BPA-Solicited Technical Review of "Echo Meadows Project Winter Artificial Recharge: Final Report for 2001 Baseline"

**“Echo Meadows Project Winter Artificial Recharge:
Final Report for 2001 Baseline”**

Review of Interim Progress Report and Associated Data for
**“Echo Meadows Project Winter Artificial Recharge:
Final Report for 2001 Baseline”**

As you requested we have performed a technical review of the report "Echo Meadows Project Winter Artificial Recharge: Final Report 2001 Baseline" (December 2002, BPA Project 2001-015-00). The scope of the review includes an assessment of the data collection and analysis presented in the report. As part of the review, we also requested data and supporting documents that were referenced in the subject report. Editorial review of the report was not within the initial scope of the review, however where issues of organization and presentation substantively diminished our ability to provide technical review, we have made suggestions for editorial improvements. A brief summary of major comments is provided below and the full text of our comments is included in the addendum. Comments in the addendum follow the organization of the report. Wherever

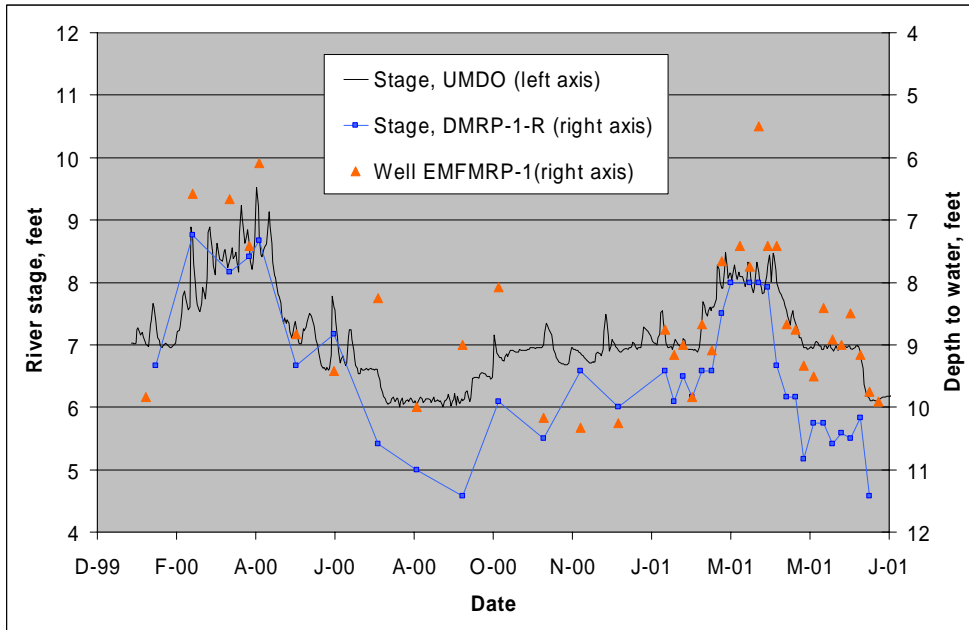
Stream depletion computations shown on page 23 are based on simplifying assumptions that need some support. The authors estimate that groundwater pumping to offset reductions in surface water availability for irrigation "could" have depleted streamflow by 20 cfs during the lowflow period. The first implicit assumption is that all groundwater pumped would have discharged to the river. Other possible fates for the groundwater are discharge to

evapotranspiration (via wetlands created by an elevated water table) or subsurface outflow from the area. Subsurface outflow is especially likely if any of the groundwater pumped was from the deeper basalt aquifers. The stated assumption that all captured groundwater would have discharged to the river during the 150-day irrigation season cannot be justified. In fact this assumption is contrary to the finding presented later in the report that artificial recharge applied in the winter months would discharge to the river in late summer and early fall. If water applied in winter would not discharge until 6-8 months later, then groundwater pumped in the summer could not have discharged instantaneously to the river. In summary, the estimate of 20 cfs for streamflow depletion caused by pumping is extremely tenuous and is dependent on some assumptions that have not been justified.

The discussion of historic return flows (page 25) concludes that summer baseflow in the Echo Meadows reach has decreased from 45 cfs to 10 cfs since the 1970s. This is a critical piece of information inasmuch as it forms the basis of the need for the proposed artificial recharge project. A much more thorough discussion and presentation of data is warranted and the data that form the basis of the conclusion should be presented in graphical form. A reference is made to figure 2 of the draft progress report which apparently shows data collected by OWRD in 1985-86 and 1991-97 that indicates a reduction from 20 cfs to 10 cfs during this period. The actual figure number in the progress report is 5 (page 14), however, at least as presented in the figure it is impossible to discern a significant reduction in baseflow from the data. Another reference is made to "Ely (2000)" for data that support the reports contention that baseflow was reduced from 35 cfs in 1980 to 20 cfs in 1985-86. The Ely reference does not appear in "Cited References" on page 54 and could not be supplied by the authors for this review. Finally, the data used by Graham (2002) that is also cited to support a mean summer baseflow of 45 cfs in the "1940-1970s" should also be presented in this section. If there were one published report that presented a comprehensive interpretation of the return flow data, it could be cited and summarized to support this very important aspect of the hydrologic conditions in the Echo Meadows. However, since most of the discussion references draft and unpublished work, a more complete analysis should be presented in this report. That analysis should address the question of how the datasets, which were collected by different agencies and at different times and locations, were compared. The effects of variable climatic conditions should be considered as should the effects of measurement error at the various streamflow conditions during each measurement.

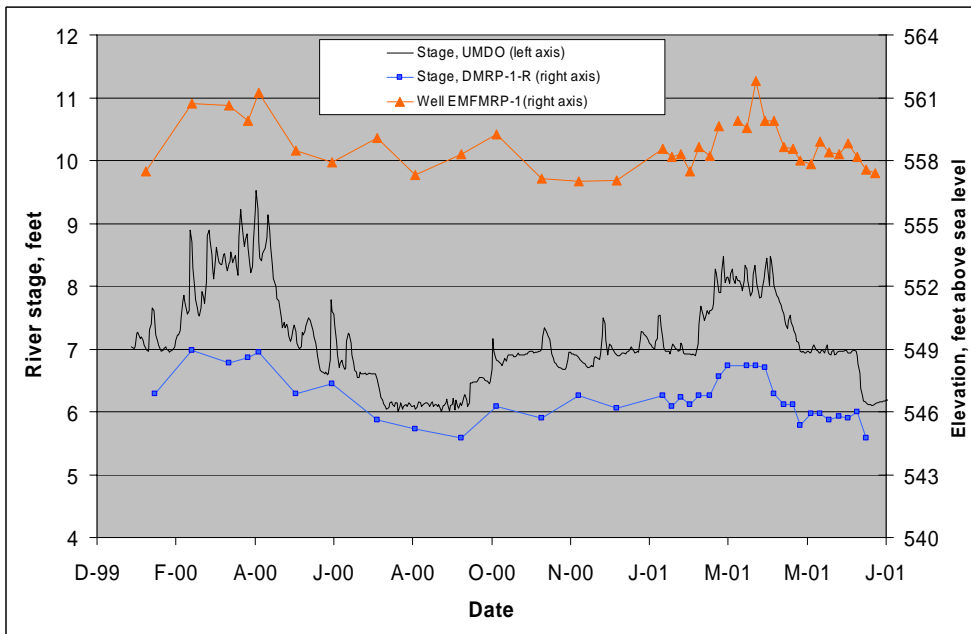
Groundwater and surfacewater level measurements are shown in figures 3-5 and discussed on pages 27-29. Figure 3 is presented as a representative hydrograph showing the relation between the water table elevation and the stage of the river. The 3-ft rise in the water table at well EMFMRP-1 from January through March 2000 is attributed to "irrigation and river stage". We question whether irrigation has any part in this rise inasmuch as the rise occurred prior to March 1st and significant Irrigation did not occur until at least mid-April. It is more likely that the rise is caused by the river stage which peaked in early April after a 2-3 ft rise. We plotted the stage measurements from the gage below the Dillon diversion (UMDO on the USBR web site) against the groundwater levels from well EMFMRP-1 (see below). The data in figure 4, "Umatilla River Stage", are labeled as DMRP-1-R; we plotted these data from the CD on the hydrograph below and discovered that the measurements are apparently "depth to water surface" below some datum. (Figure 4 does not have the y-axis labeled and does not define either of the two series of data displayed on the graph.) When these data are plotted together, it is readily apparent that stage at UMDO and the "depth" data at DMRP-1-R show similar trends to the well hydrograph for EMFMRP-1 as would be expected in a well only 100

When presenting data from sites that have been surveyed, the authors are encouraged to convert all water level and stage measurements to a consistent datum (sea level) so that elevation relations between groundwater levels, and between groundwater levels and river stage may be determined. In the hydrograph below, the data from well EMFMRP-1 and river stage site DMRP-1-R have been adjusted to sea level using the reference elevations listed in Appendix A. When plotted in this way it is apparent that the water table is consistently about 12 feet above the river level. This gradient shows that groundwater discharges to the river throughout the year, although discharge during periods of high river stage is probably reduced due to the reduced lateral gradient toward the river.
